ADDENDUM NO. 5

KAMEHAMEHA HIGHWAY DRAINAGE AND SAFETY IMPROVEMENTS
VICINITY OF LANIAKEA BEACH (MP 3.06 TO MP 3.54)

PROJECT NO. 83B-01-09

October 5, 2023

METAL GUARDRAIL TYPE 3 THRIE BEAM SECTIONS AND DETAILS

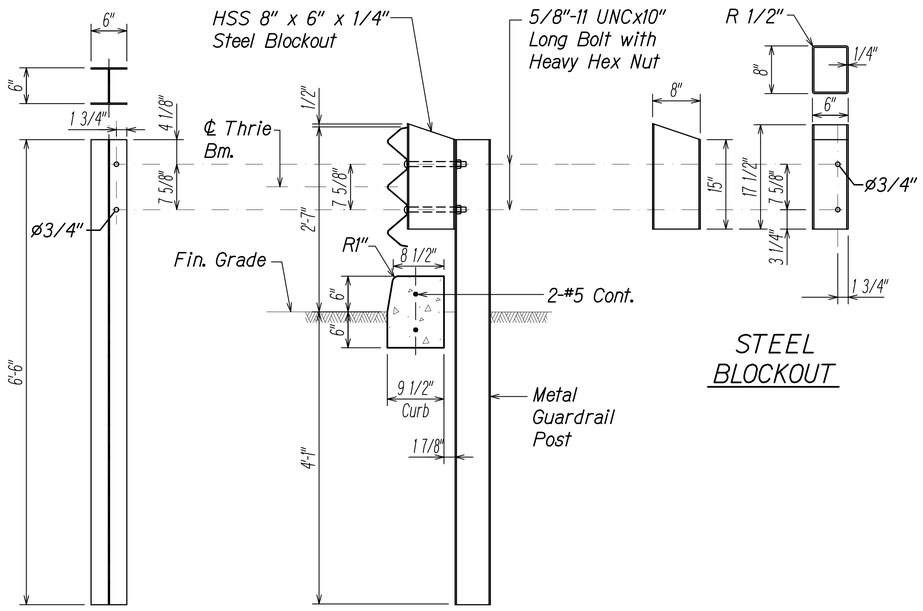
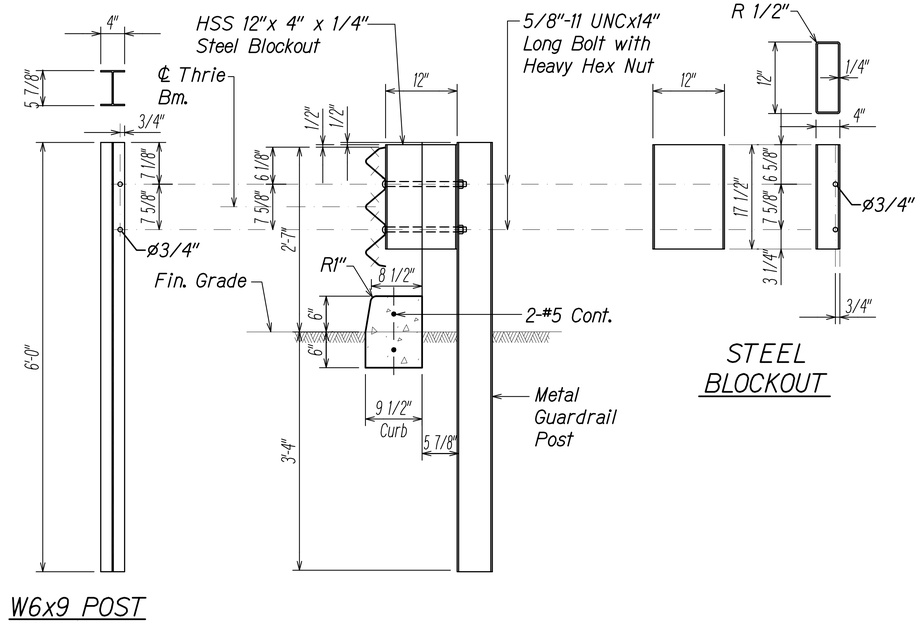
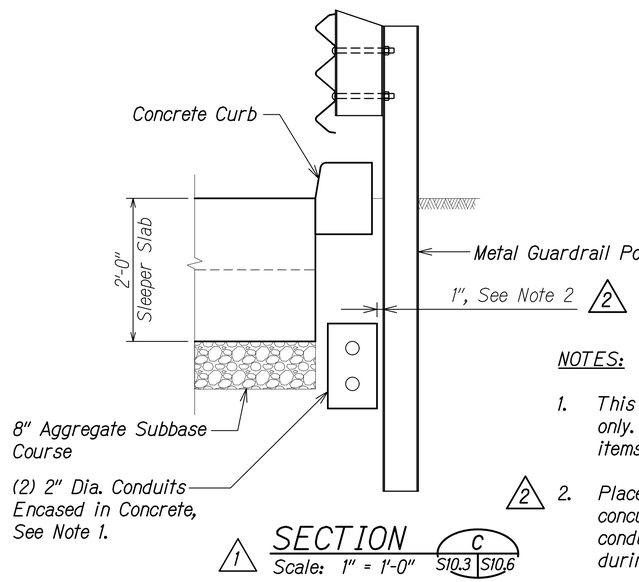
1. This condition occurs on the mauka side of the structure only. The Contractor shall coordinate the placement of various items to ensure proper installation.
2. Placement of metal guardrail posts may need to be performed concurrently with the placement of the concrete encased conduits. The location of these conduits shall be coordinated during the construction of the utility beam.

DATE	REVISION
10/2/23	2 Addendum 5 Add Note
9/19/23	1 Addendum 3 New Section
